To: T10 Technical Committee  
From: Rob Elliott, HP (elliott@hp.com)  
Date: 14 June 2006  
Subject: 06-263r1 SAS-2 Spread-spectrum clocking

Figure 2 — Downspreading SSC in SAS-2

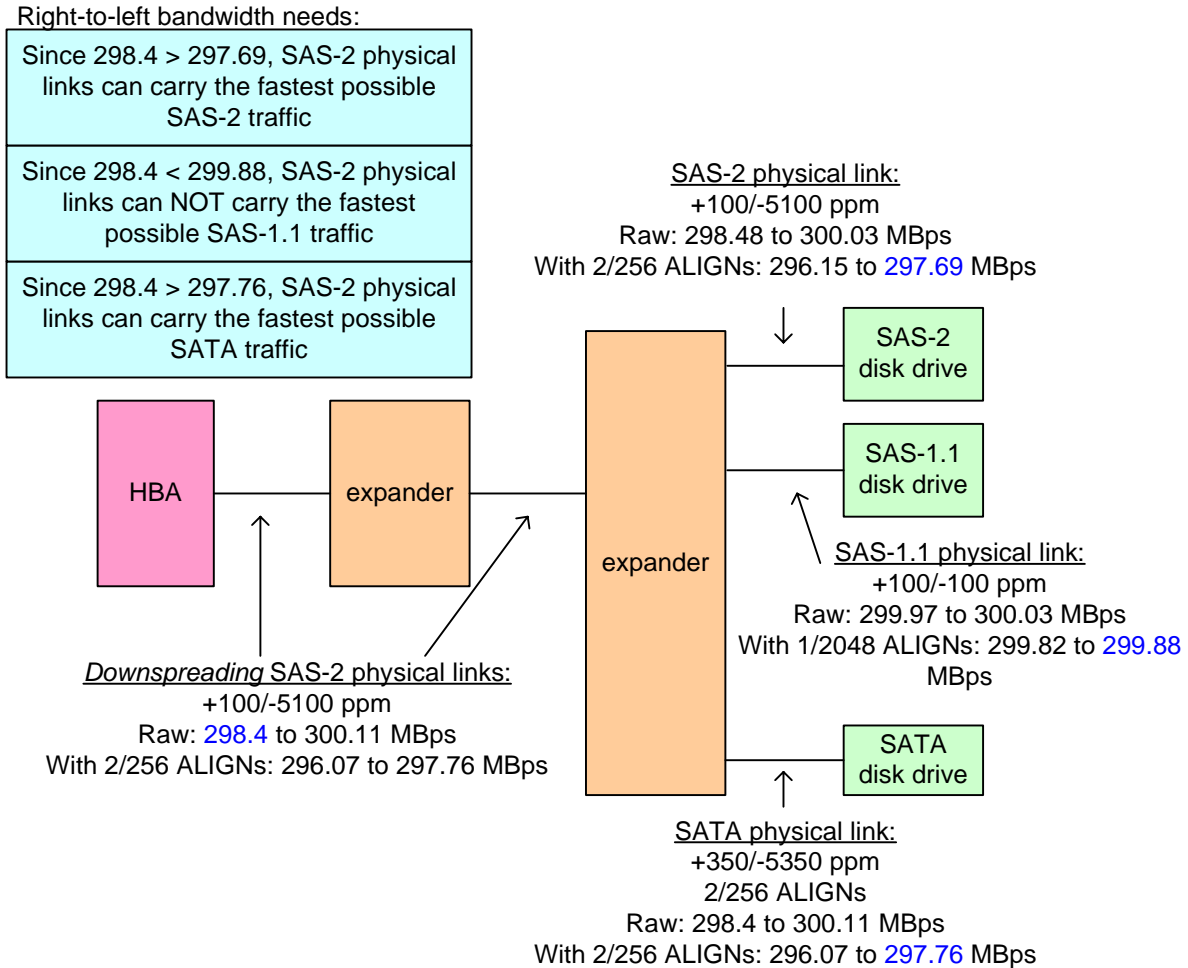
Figure 2 shows the problem with adding downspreading SSC (e.g., +0/-5000 ppm) to SAS-2. This works fine for SATA phys, which also downspreads, but fails if there is a SAS-1.1 phy in the SAS domain that does not support SSC. If such a phy is attached anywhere in the SAS domain, its traffic overflows any SAS physical link (either expander-to-expander or expander-to-end device) implementing downspreading SSC. Downspreading SSC would have to be disabled everywhere if any non-SSC device were added to the SAS domain.

**Figure 3 — Upspreading SSC in SAS-2**

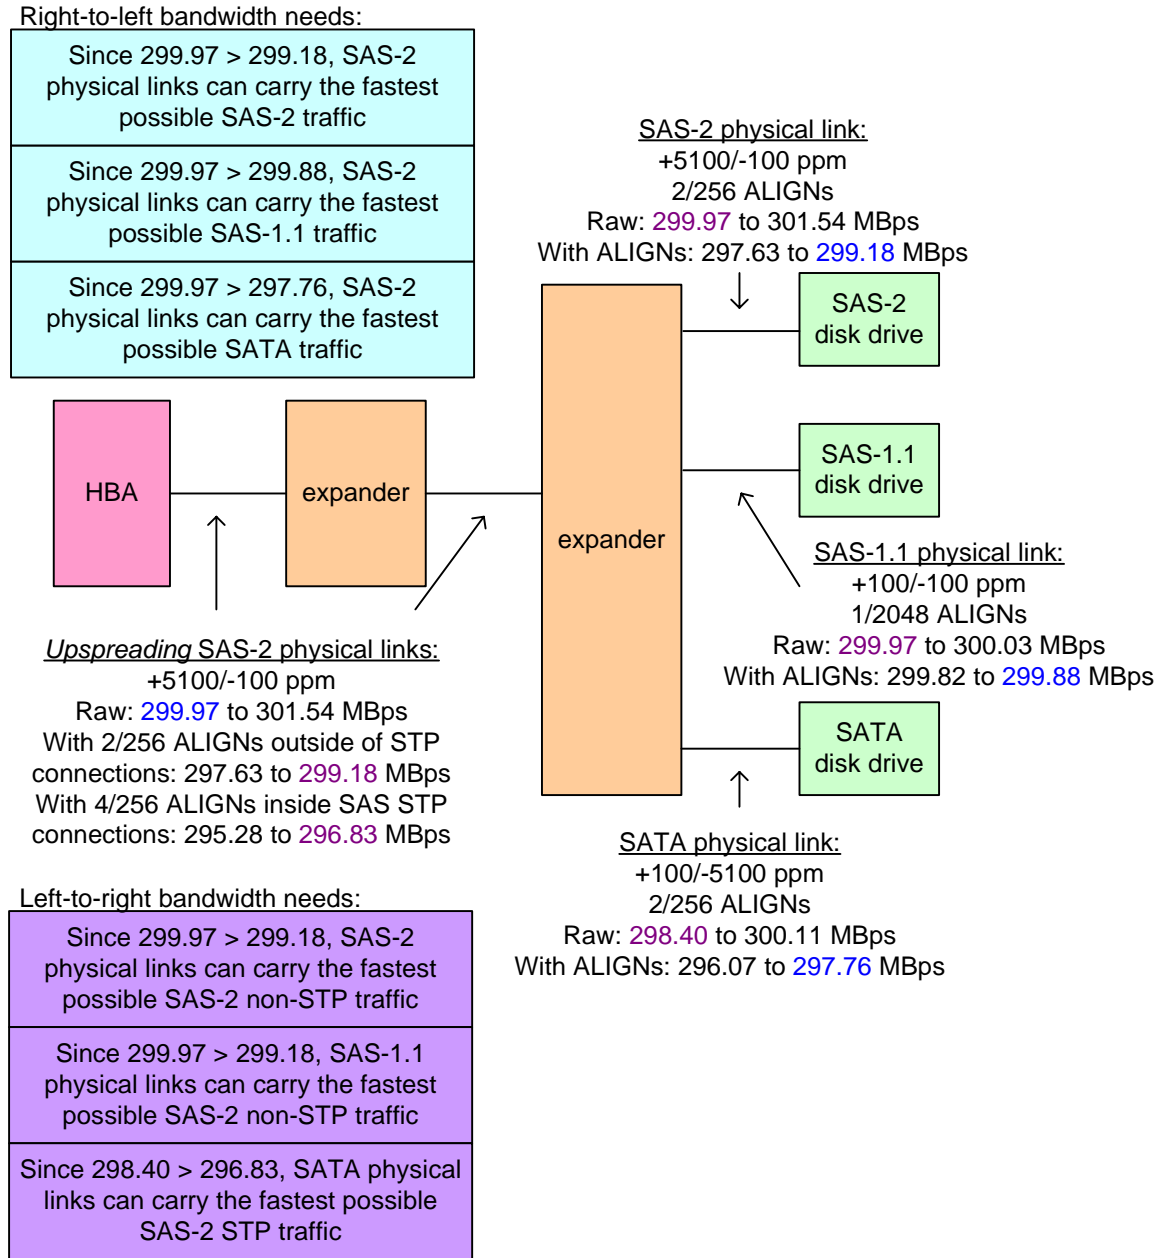
Upspreading SSC (e.g., +5000/-0 ppm) ensures that SAS-2 physical links will always be equal or faster than any SAS-1.1, SAS-2, or SATA physical links. Figure 3 shows upspreading SSC.

Extra ALIGNs are needed to accomodate SSC.

**Figure 4 — Three clock trees**

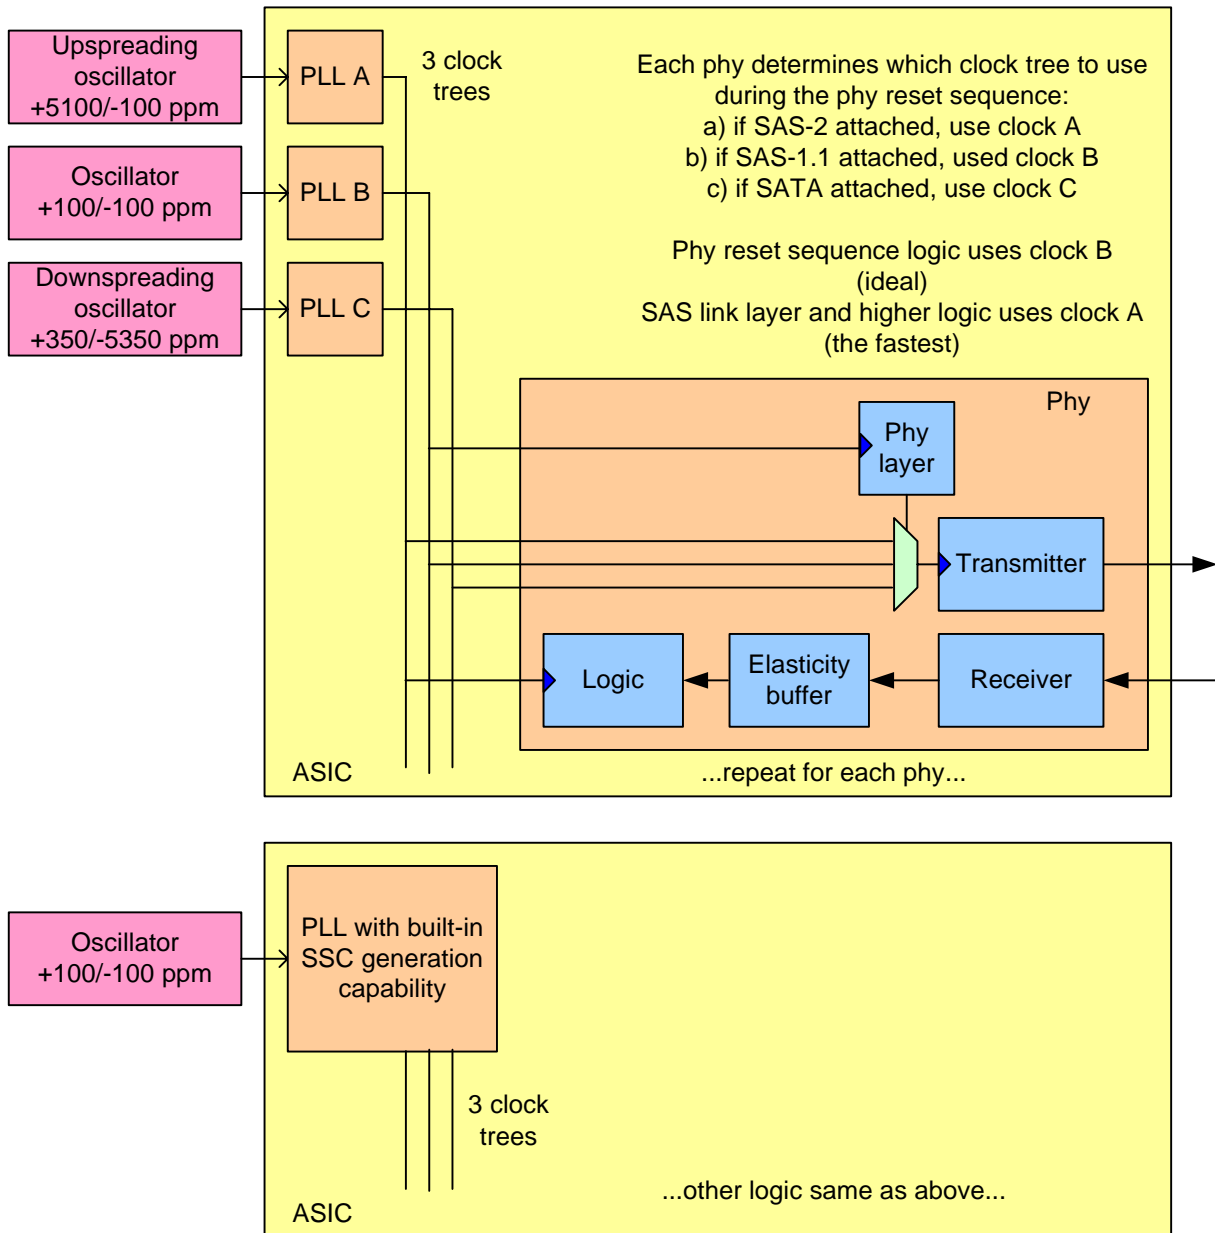
This require an expander ASIC to have 3 clock trees. Figure 4 shows the problem.
